Architect's Supplemental Instructions

Architect's ASI No: 041

Project:
Webster University
Interdisciplinary Science
Building

Date Issued: 12/13/2016

T0804

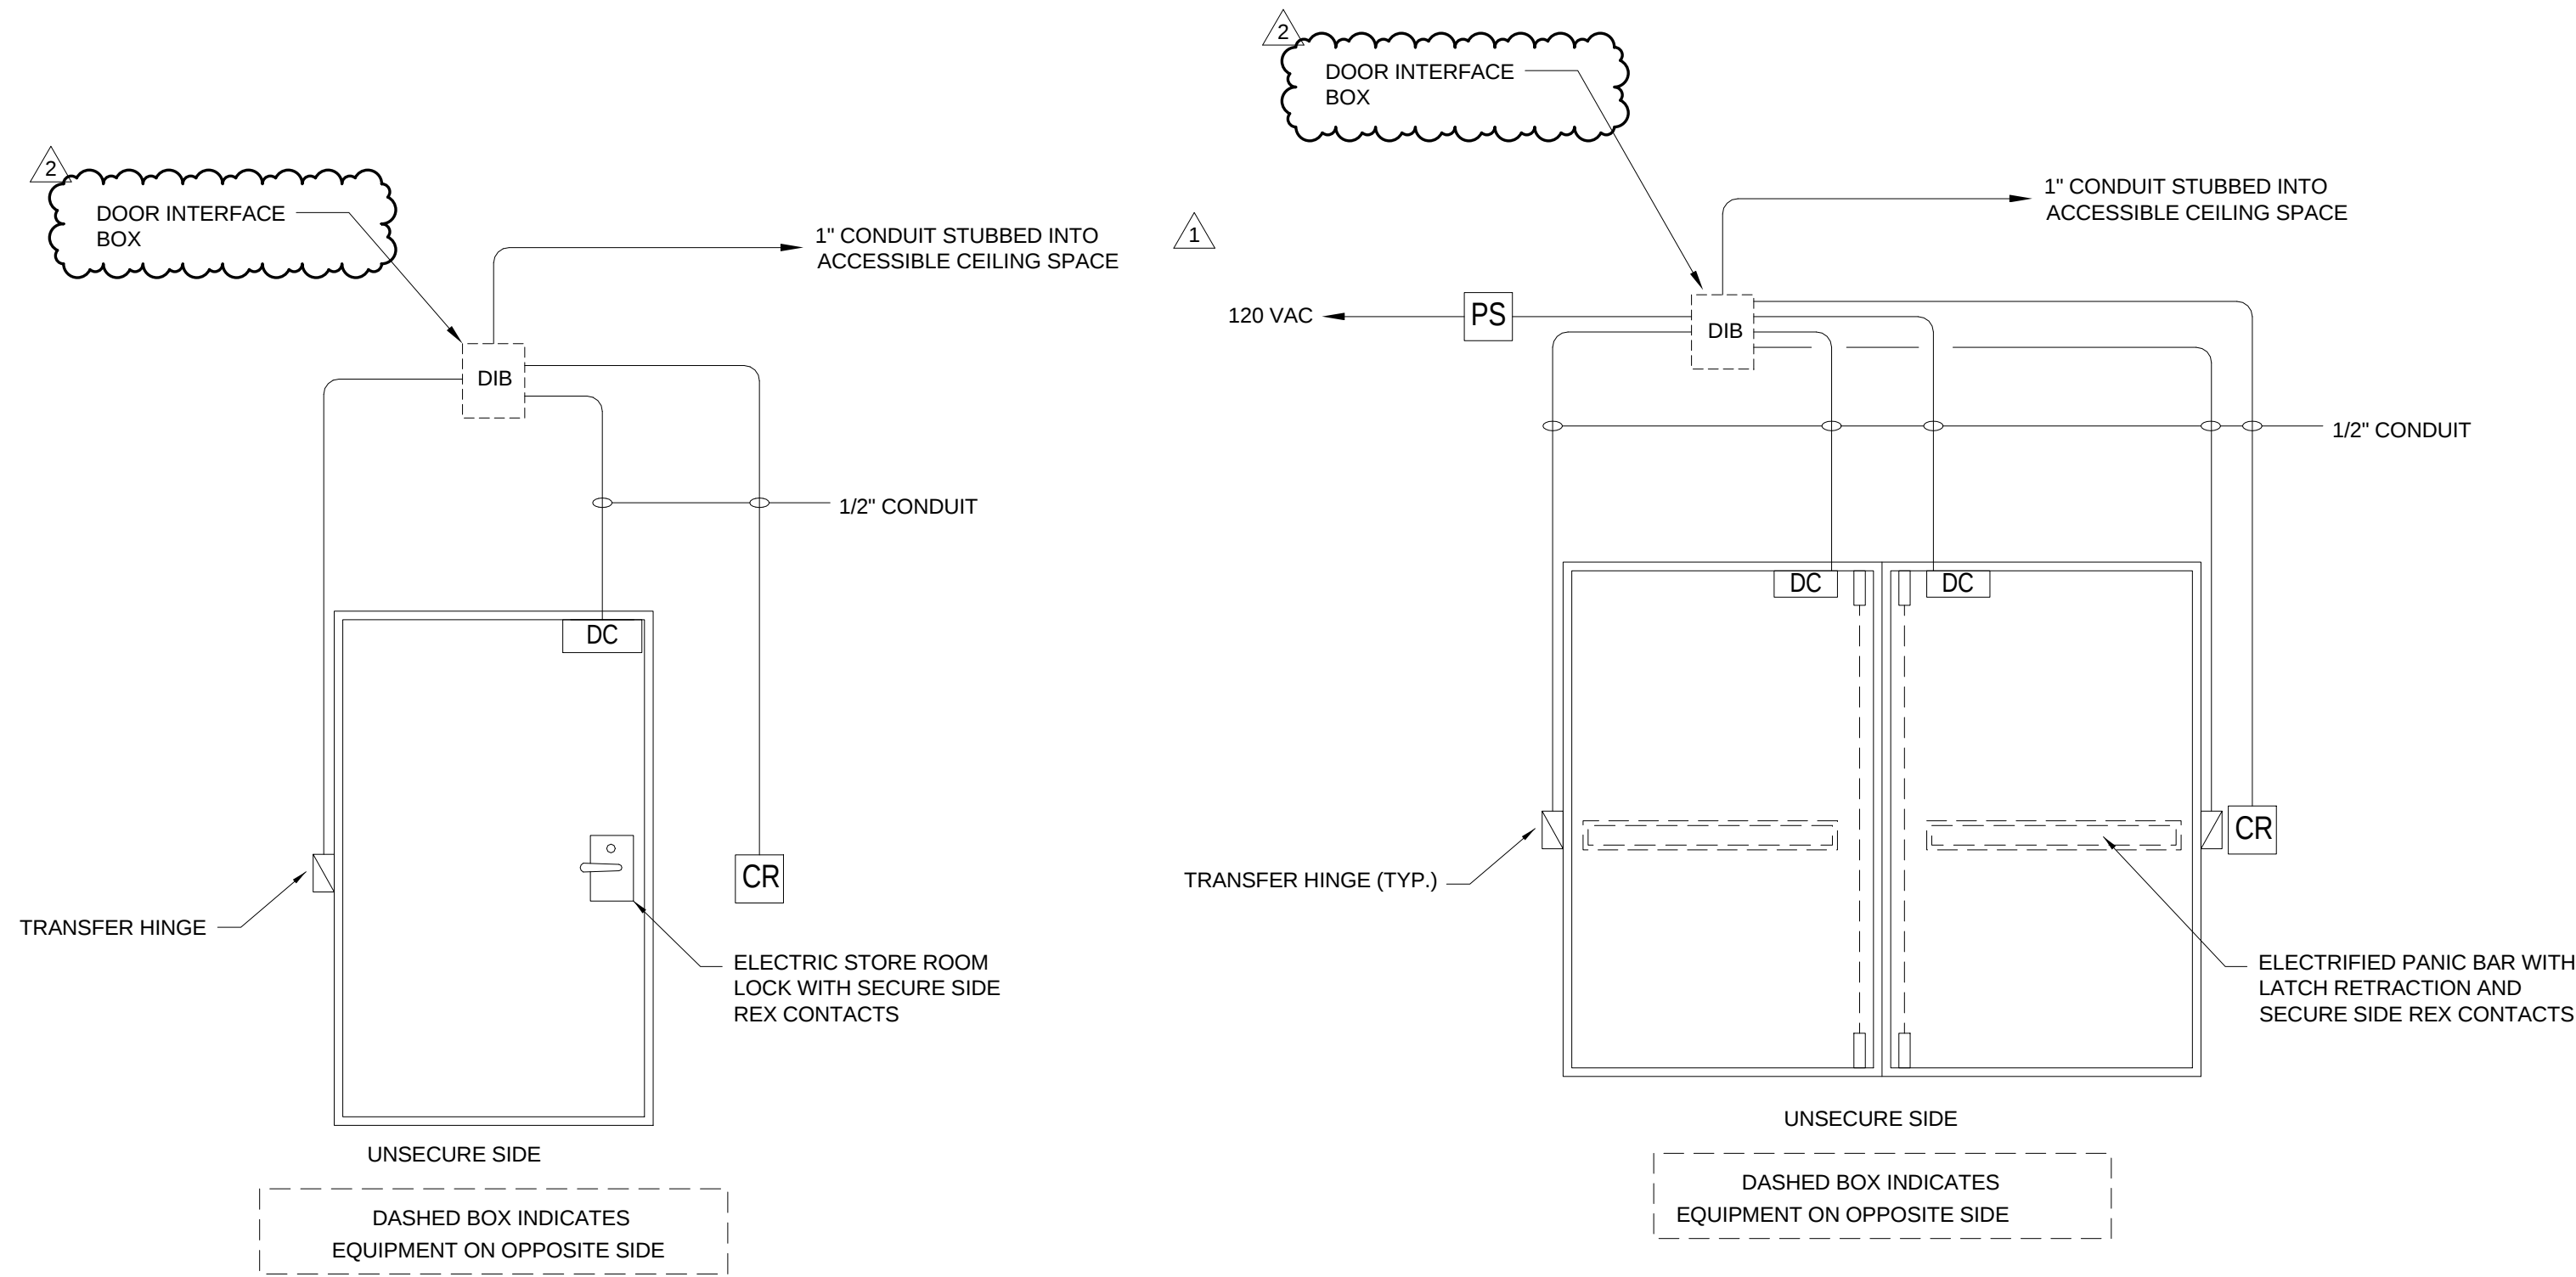
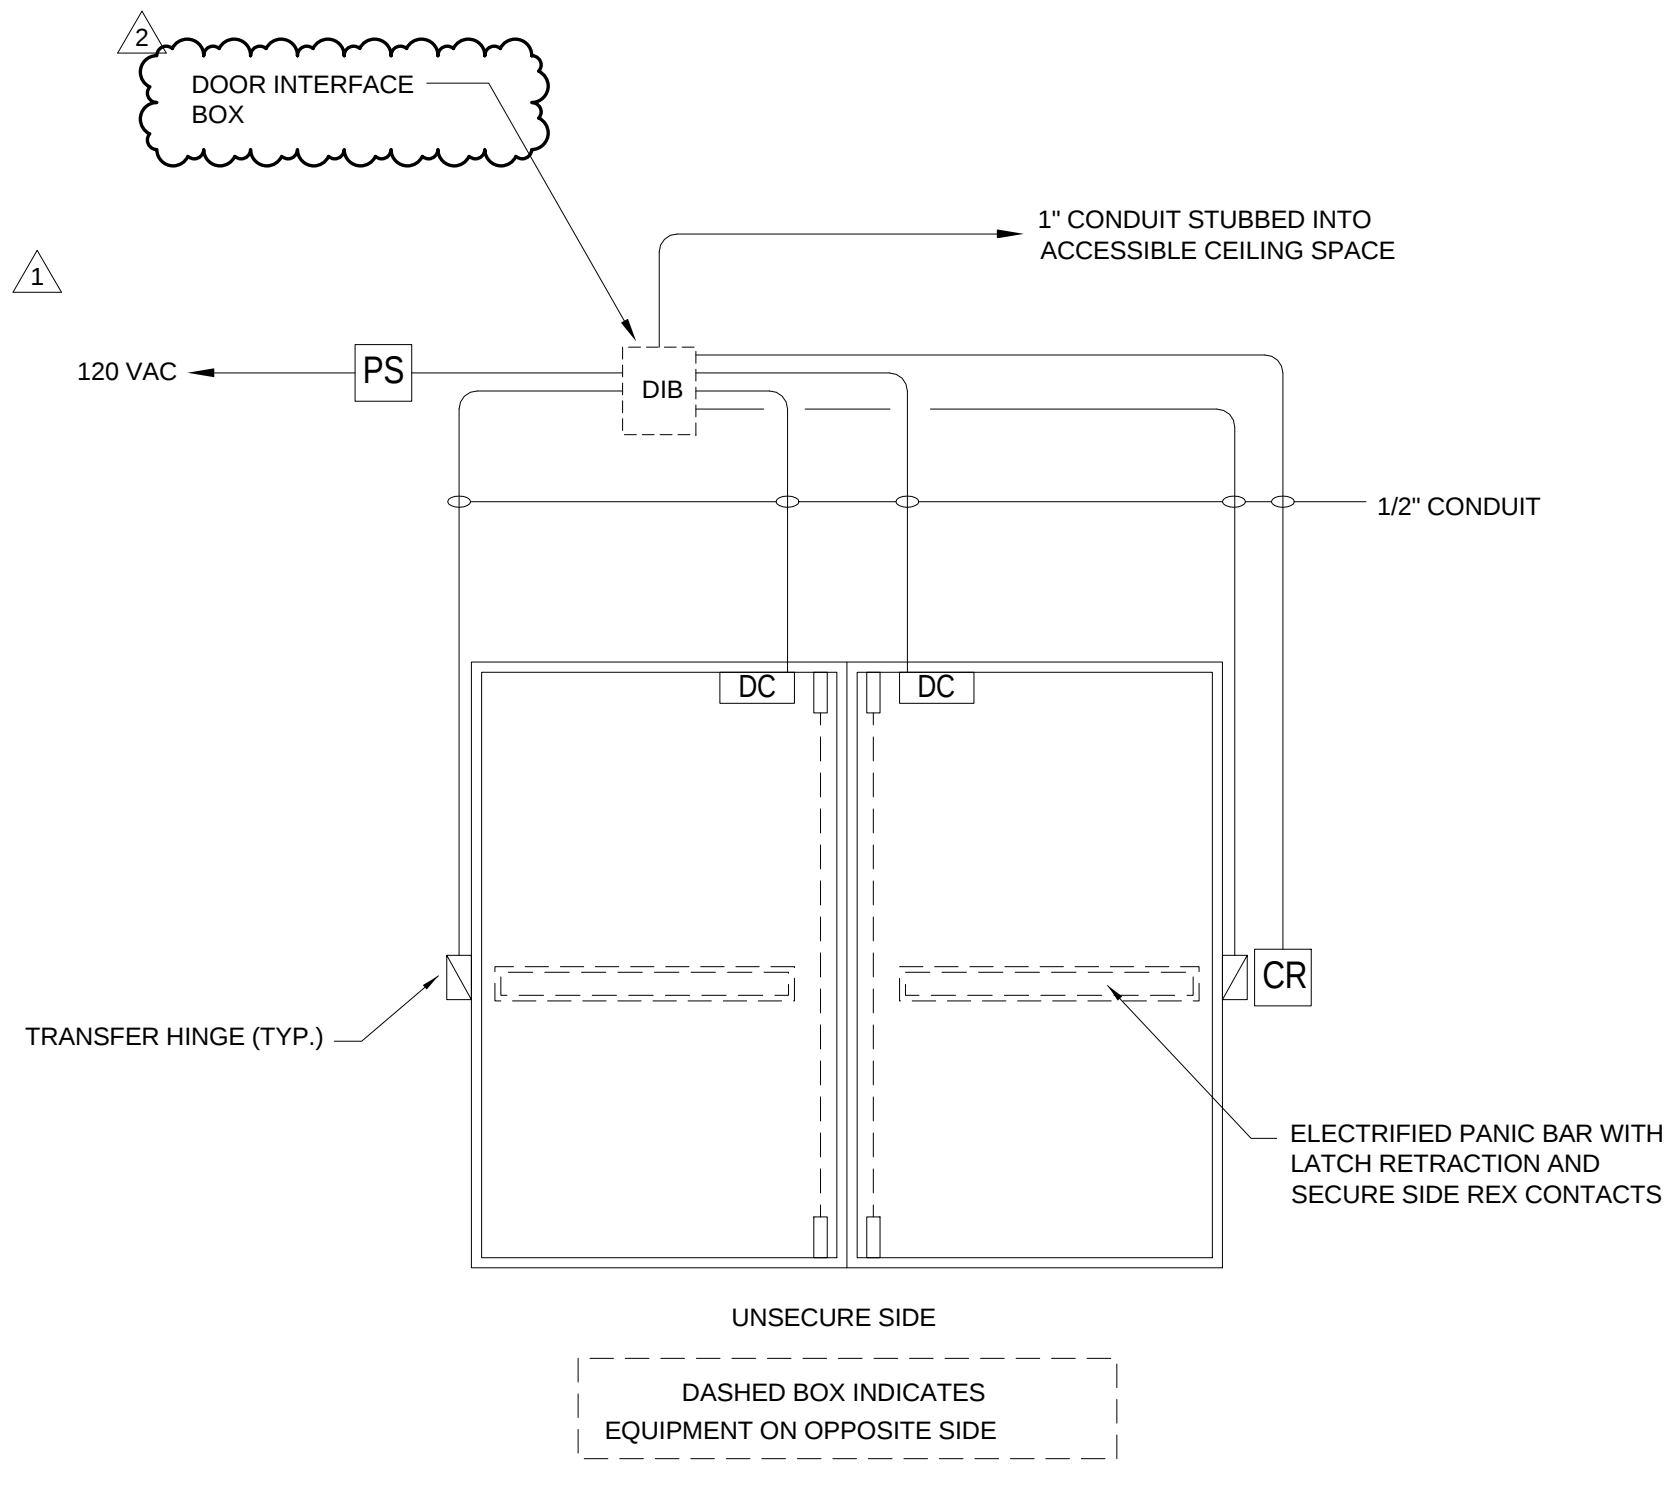
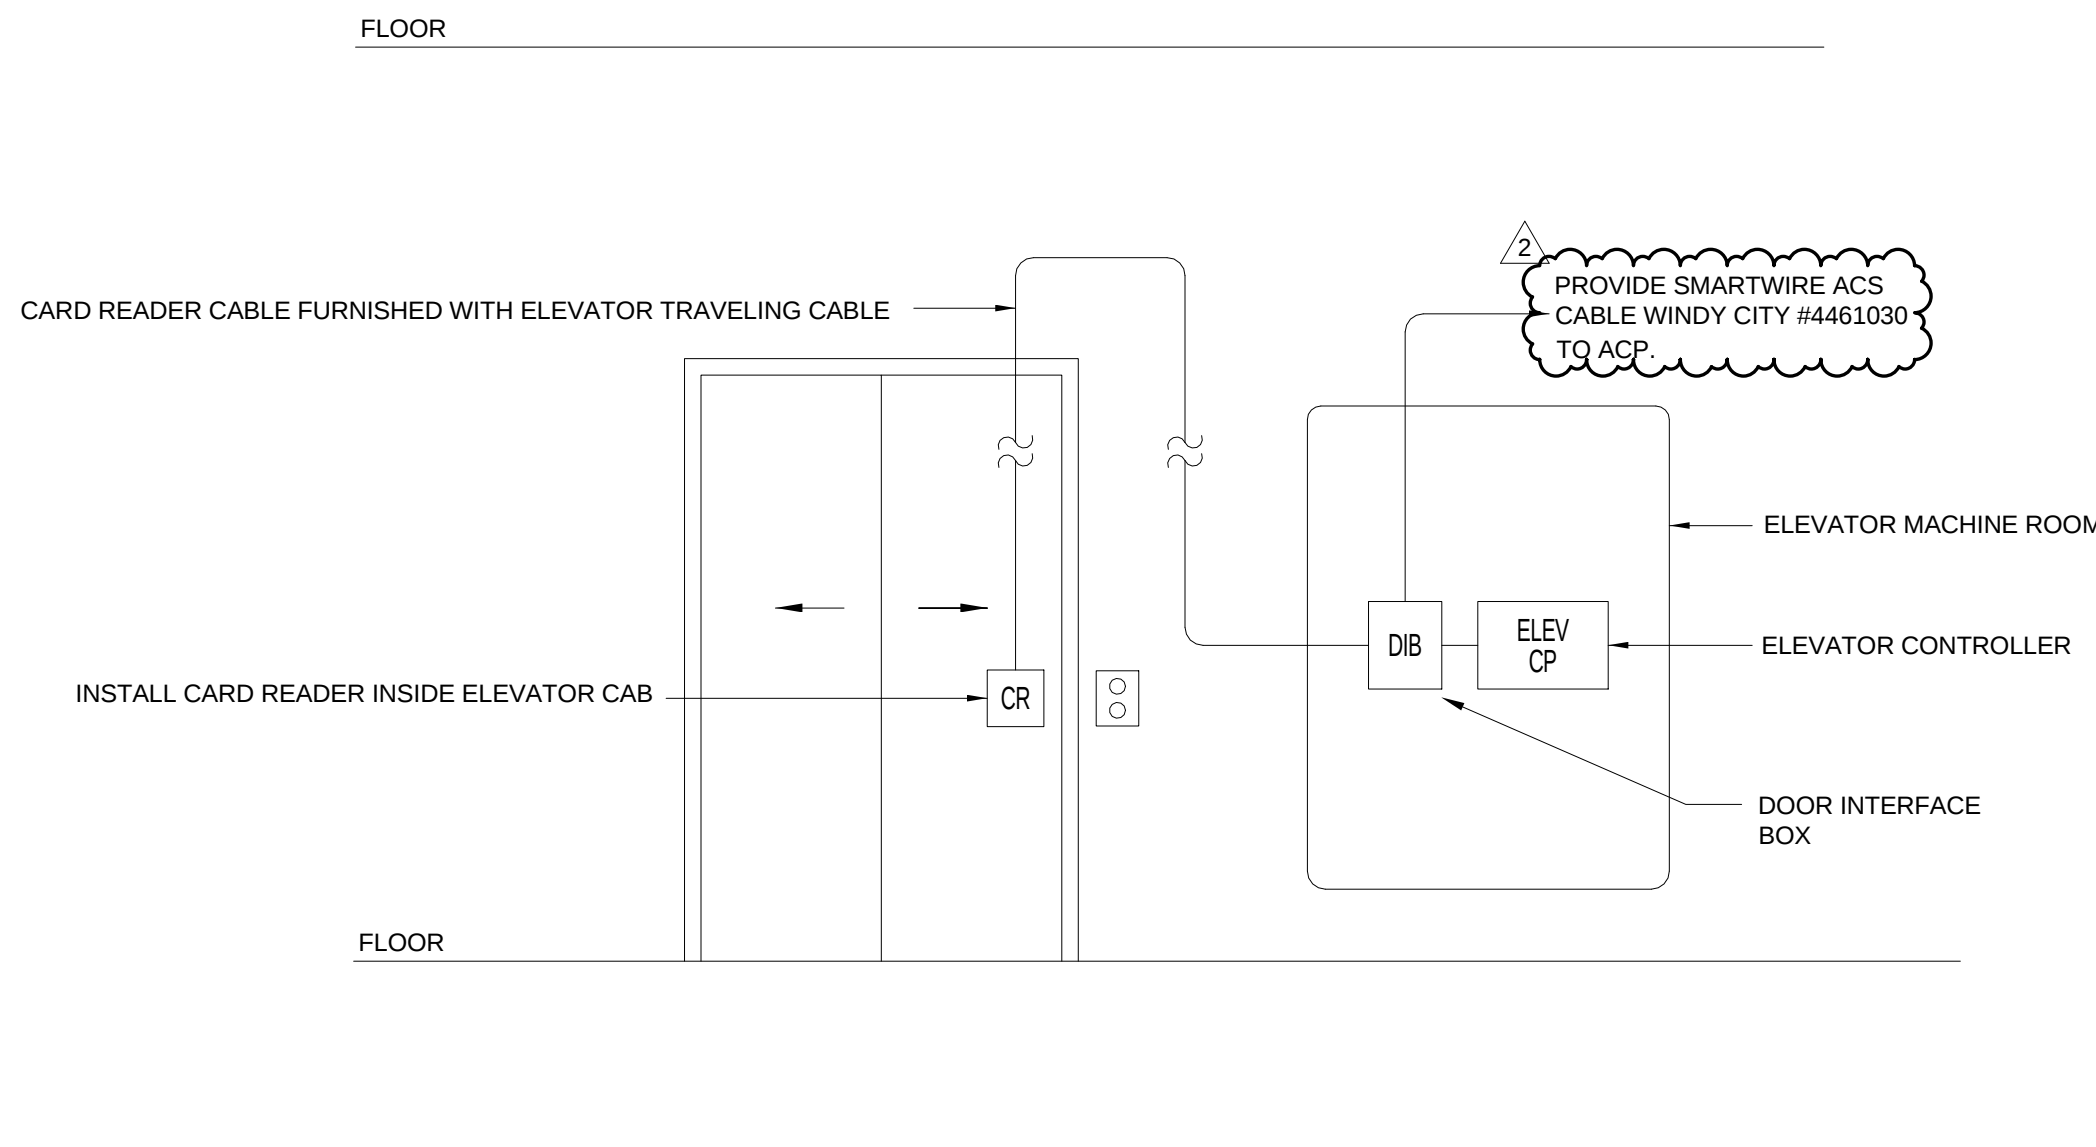
1. T0101.A – LEVEL 01 FLOOR PLAN – AREA B
 - A. Relocated access control equipment from door 170 to door 150.
2. T0803 – ACCESS CONTROL BLOCK DIAGRAMS
 - A. Revised Level 1 block diagram
3. T0804 – ACCESS CONTROL DETAILS
 - A. Revised Door Interface Boxes
 - B. Revised Access Control System cable
 - C. Revised General Notes
 - D. Revised Responsibility matrix
